**STATE OF CONNECTICUT
CONNECTICUT SITING COUNCIL**

IN RE: :
 :
 : DOCKET NO. 510
 :
 NEW CINGULAR WIRELESS PCS, LLC :
 D/B/A AT&T AND TARPON TOWERS II, :
 LLC APPLICATION FOR A CERTIFICATE :
 OF ENVIRONMENTAL COMPATIBILITY :
 AND PUBLIC NEED FOR THE :
 CONSTRUCTION, MAINTENANCE AND :
 OPERATION OF A :
 TELECOMMUNICATIONS FACILITY : August 1, 2022
 LOCATED AT 92 GREENS FARMS ROAD,
 WESTPORT, CONNECTICUT

**NEW CINGULAR WIRELESS PCS, LLC D/B/A AT&T AND TARPON
TOWERS II, LLC RESPONSES TO CONNECTICUT SITING COUNCIL
PRE-HEARING INTERROGATORIES DATED JULY 8, 2022**

Existing Coverage
850 MHz LTE

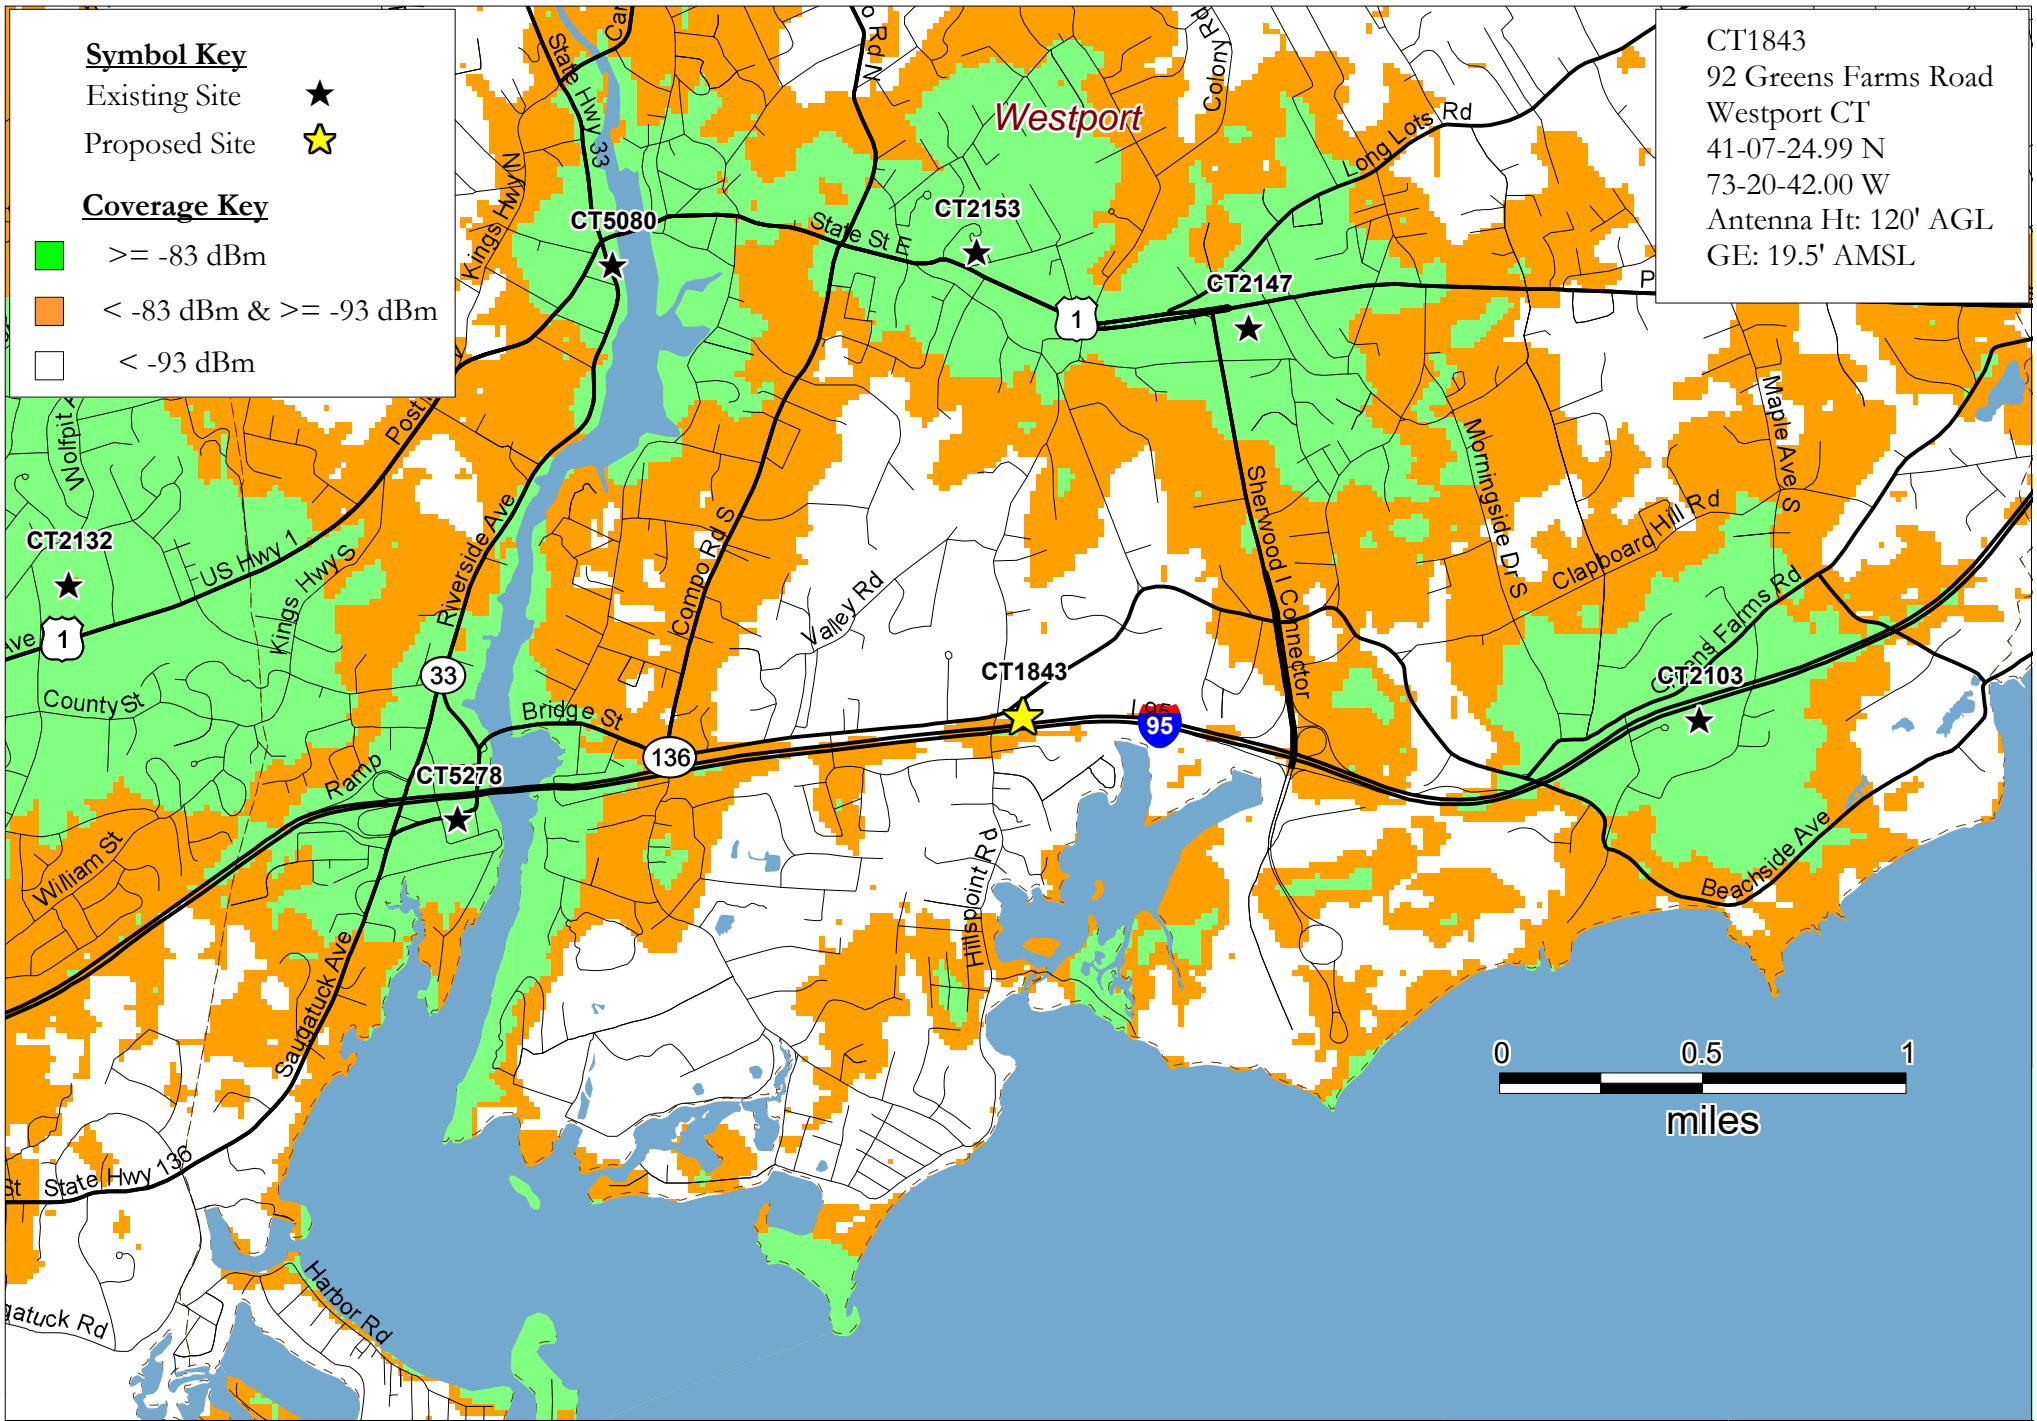
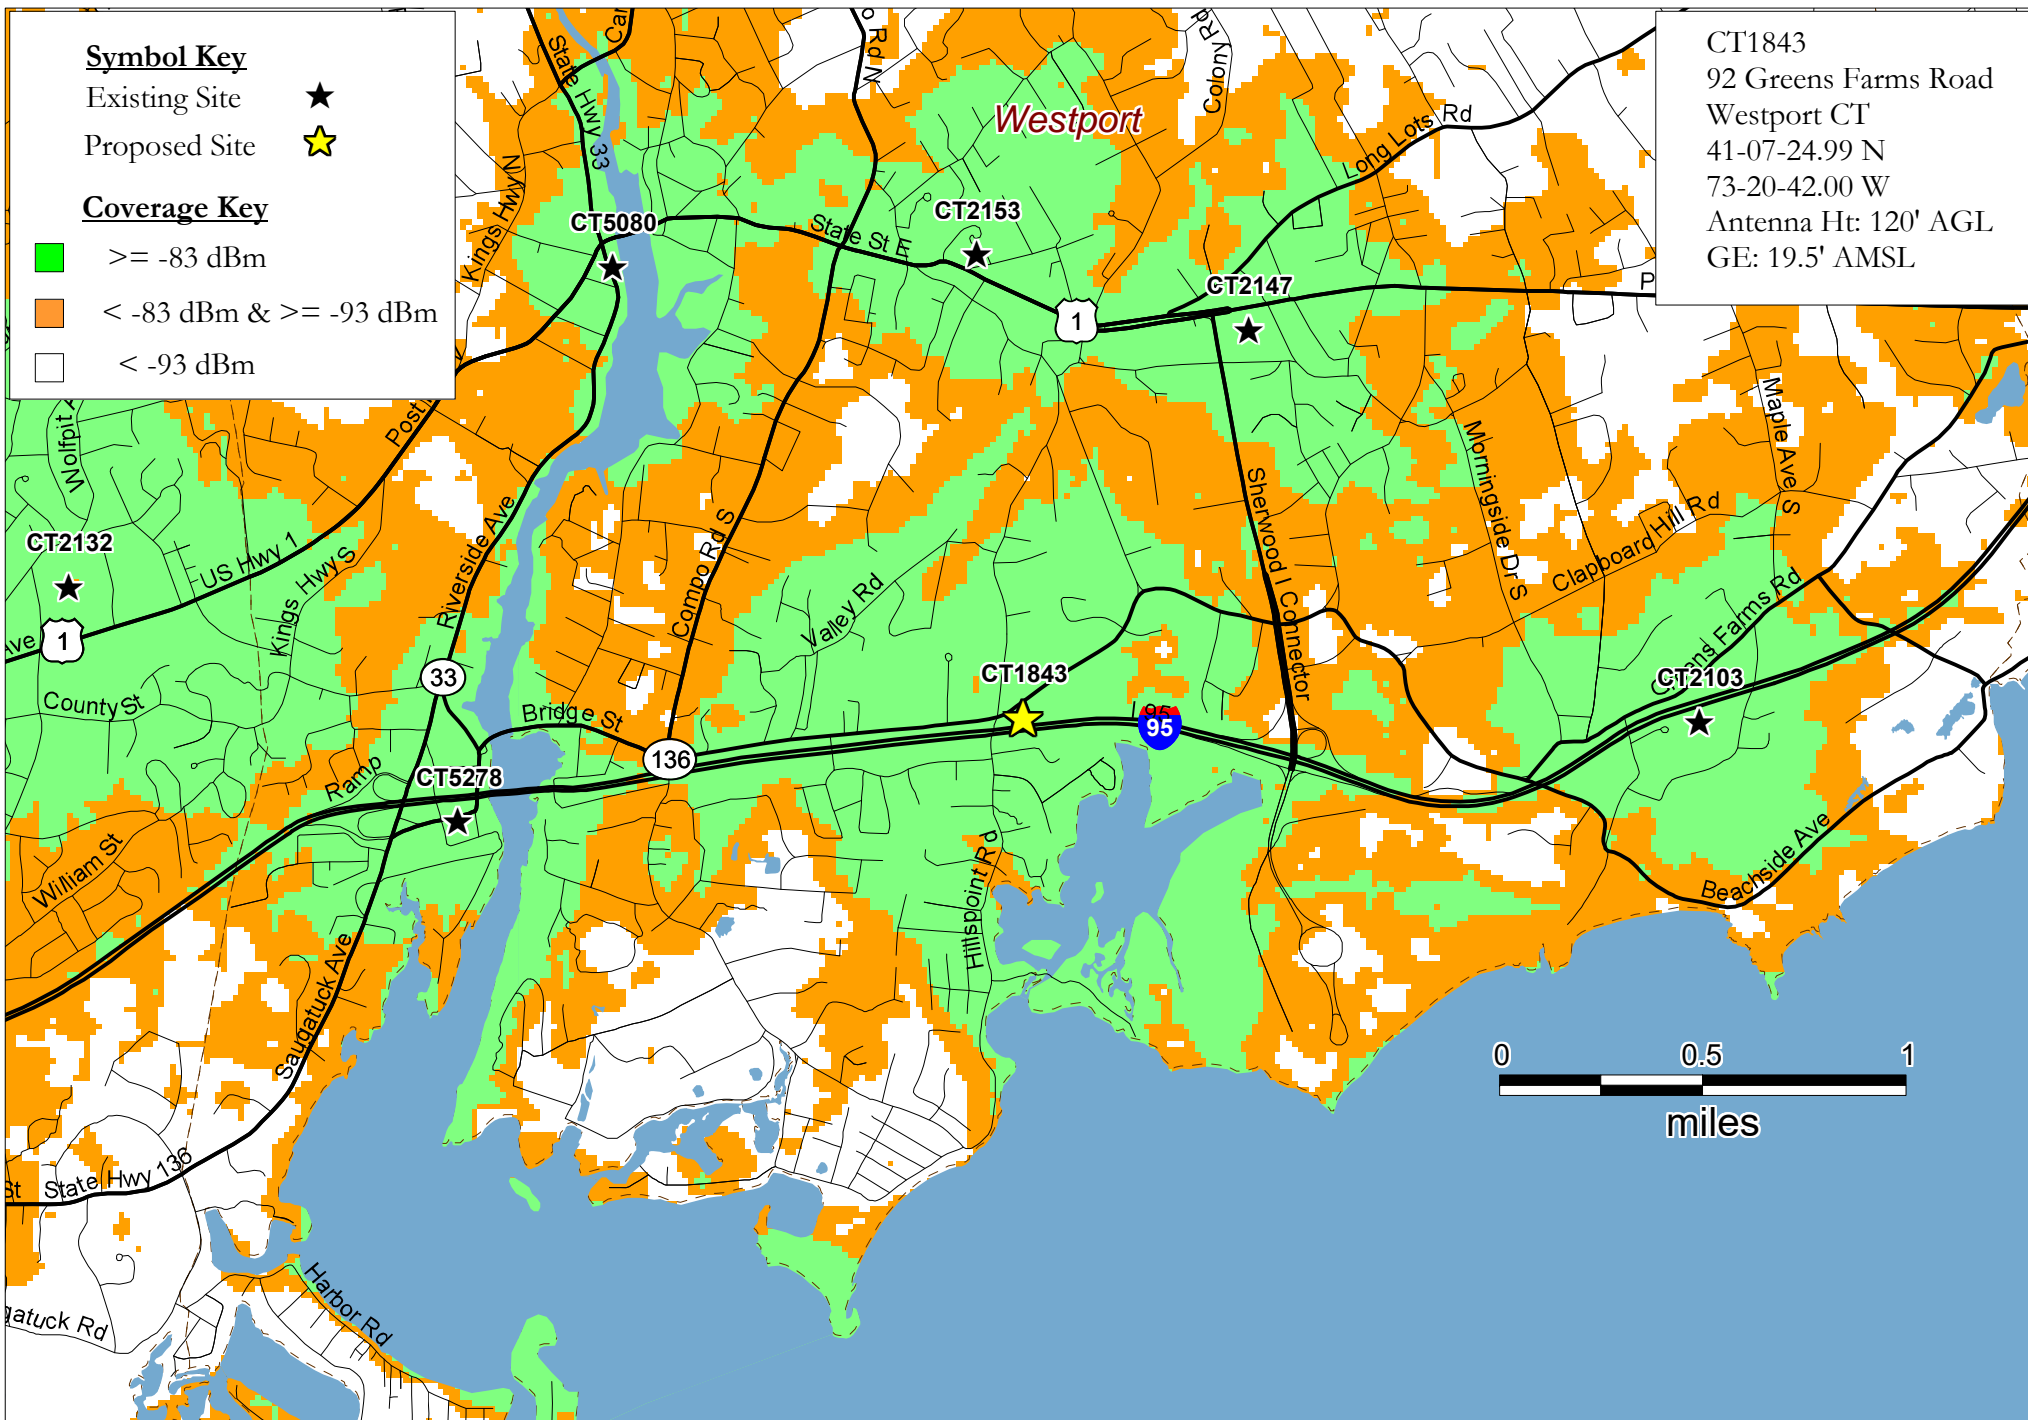
35. What is AT&T's existing and predicted coverage footprint from the proposed site (in square miles), at each frequency that would be installed?

Please see the coverage plots included in Exhibit 28. The predicted coverage footprints are as follows:

**CT SITING COUNCIL DOCKET NO. 510
RESPONSE TO COUNCIL INTERROGATORY #48
WESTPORT
92 GREENS FARMS ROAD
WESTPORT, CT 06880**

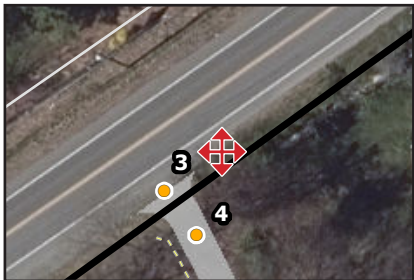
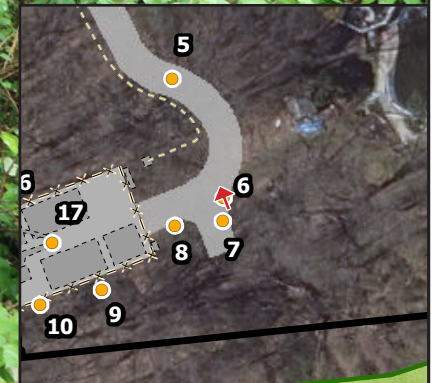
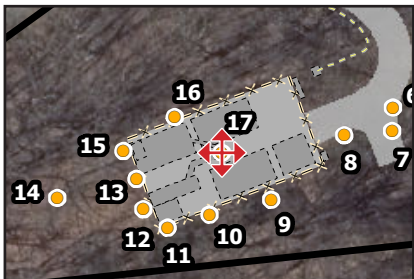
48. Please submit photographic site documentation with notations linked to the site plans or a detailed aerial image that identifies locations of site-specific and representative site features. The submission should include photographs of the site from public road(s) or publicly accessible area(s) as well as Site-specific locations depicting site features including, but not necessarily limited to, the following locations as applicable:

For each photo, please indicate the photo viewpoint direction and stake or flag the locations of site-specific and representative site features. Site-specific and representative site features include, but are not limited to, as applicable:

See attached Exhibit 48.
